## POLICY REPORT DEVELOPMENT AND BUILDING

TO: Vancouver City Council  
FROM: Director of Planning  
SUBJECT: CD-1 Rezoning - 6511 Granville Street

6511 Granville Street  
PROPOSED CONDITIONS OF APPROVAL

Figure 2: Building Layout and Setbacks

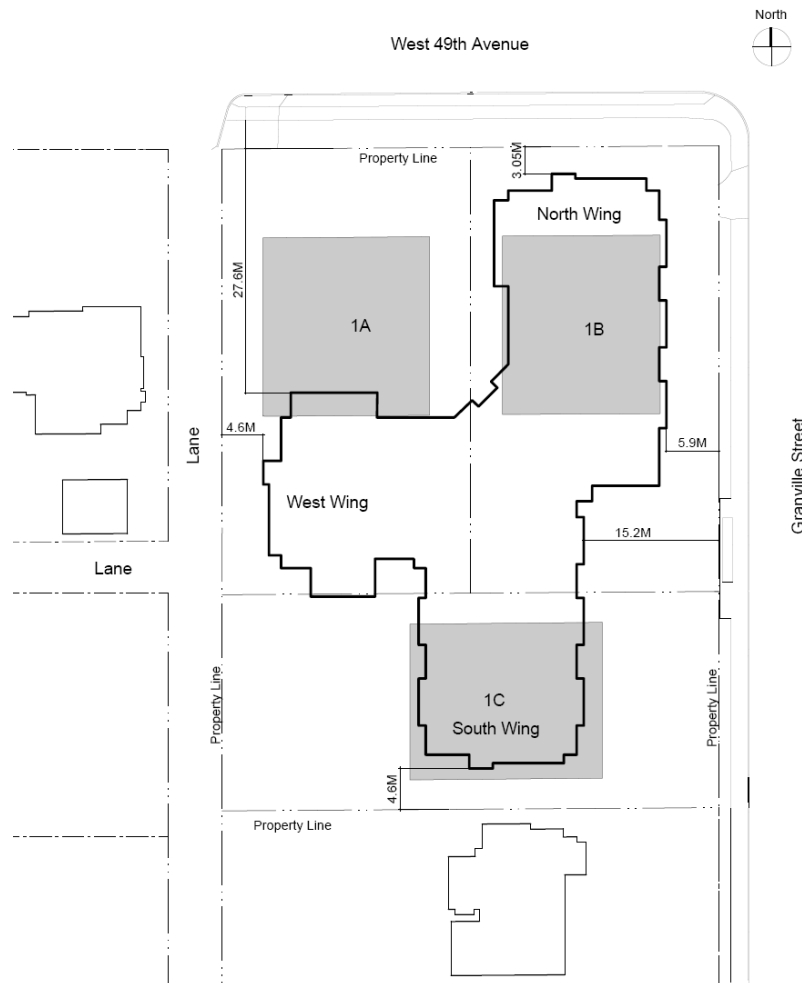
Staff conclude that the appropriate relationship has been achieved with the dwelling to the south with the prescribed setbacks and reductions in massing [see Appendix B, conditions (b)(i), (b)(ii), and (b)(iii)]. Separation from neighbours to the west is assisted by the width of the lane, and by the orientation of new windows toward the north and south. Staff find the proposed setbacks acceptable as they are used to provide common outdoor space for residents and the separation distances between the proposed building and adjacent properties are adequate. Staff have included design development conditions to ensure that the proposed setbacks are maintained if the rezoning is approved (see Appendix B).

- (i) Design development to reduce the scale and massing of those portions of the building facing single-family residential properties;

- (iii) For the south wing of the building the setback from the east property line should be comparable to the front yard dimension of neighbouring properties for approximately half the length of the site.

- (iv) For the west wing of the building the setback from the north property line should be greater than the front yard setback of neighbouring properties to the west for approximately half the length of the site.
- (v) Design development to the base of the building to avoid a horizontal expanse of relatively undifferentiated stucco, and to achieve a stronger residential expression at grade;

Note to Applicant: This can be accomplished by lowering portions of the building at the edges by approximately 1.5 m or about 13 m above grade, by varying some of the ridge lines of the project, by following grade more closely, or some combination thereof. Similar adjustments should also be considered on the north façade to reflect the residential streetscape to the west. The characteristic pitch of the gable ends should be maintained.

**North Elevation**  
 Scale: 1/8" = 1'-0"  
 Date: 1/15/10  
 Sheet: A-301

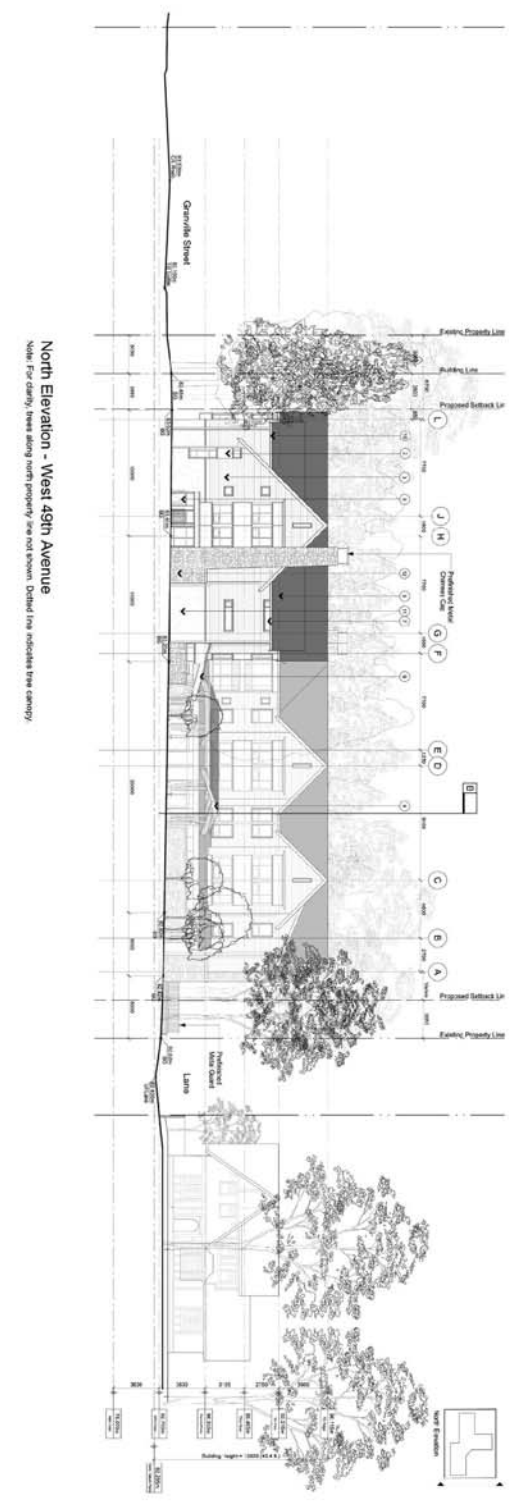
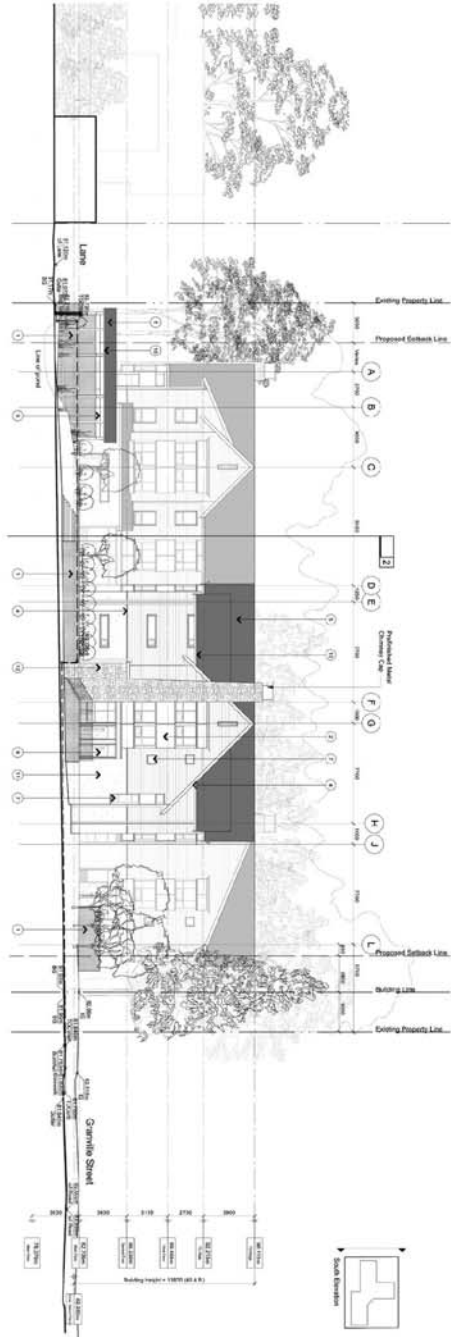
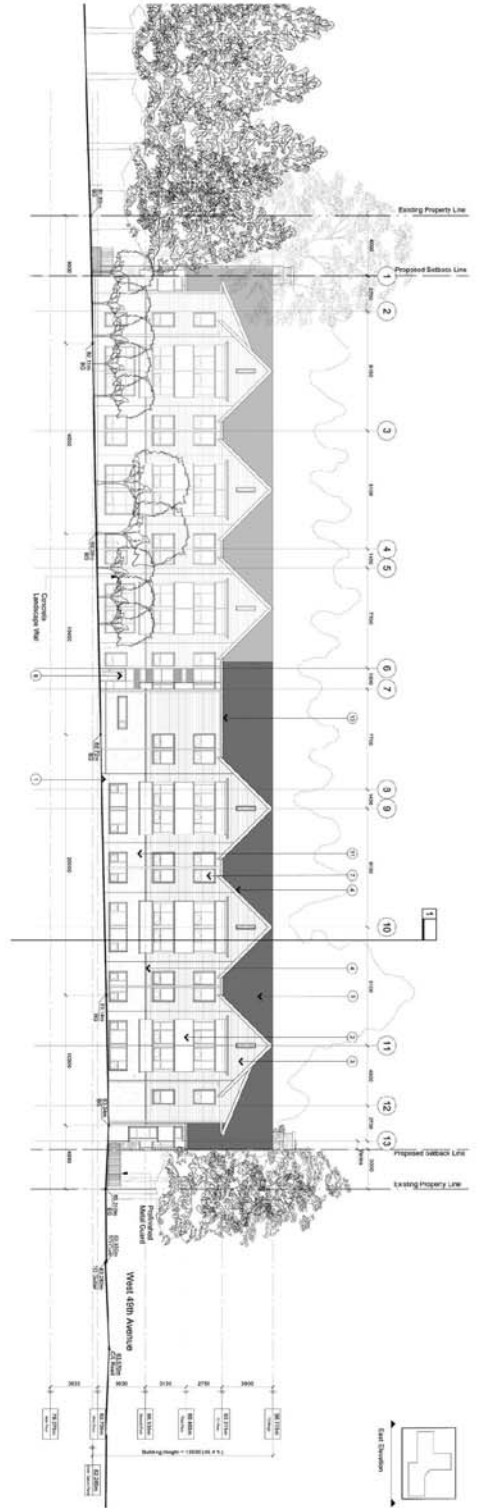
Note to Applicant: This can be addressed by using horizontal siding or masonry in place of stucco, by adding window trim that is more consistent with the residential character of the upper floors, and by adding patio doors for residents to directly access the outdoor spaces. (See also condition (b)(xvii) regarding further development of the outdoor area)

- (vi) Design development to the northeast portion of the building to better respond to this active and prominent intersection;

Note to Applicant: Consider a stronger and more distinctive expression for these bays of the building.
